Class II permissive change request letter

REF: Class II permissive change, pursuant to section 2.1043, for FCC ID: QISHG8245H

Pursuant to section 2.1043, Huawei Technologies Co., Ltd. Hereby submit a request for class II permissive change to our GPON Terminal, model no.: EchoLife HG8245H, FCC ID: QISHG8245H, Grant date: 2013-05-31.

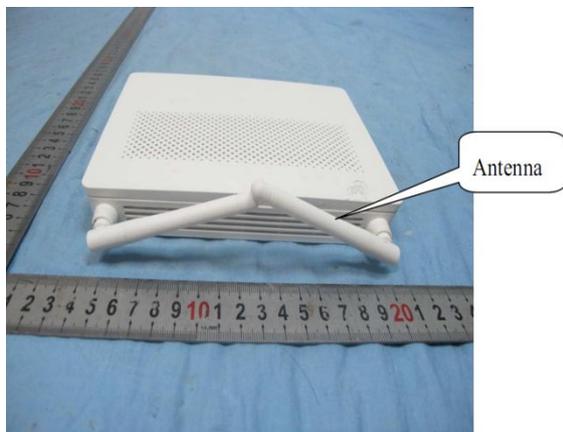
Change the external antenna, the max antenna gain is changed from 2dBi to 5dBi, the antenna type is the same. For more detail please check:
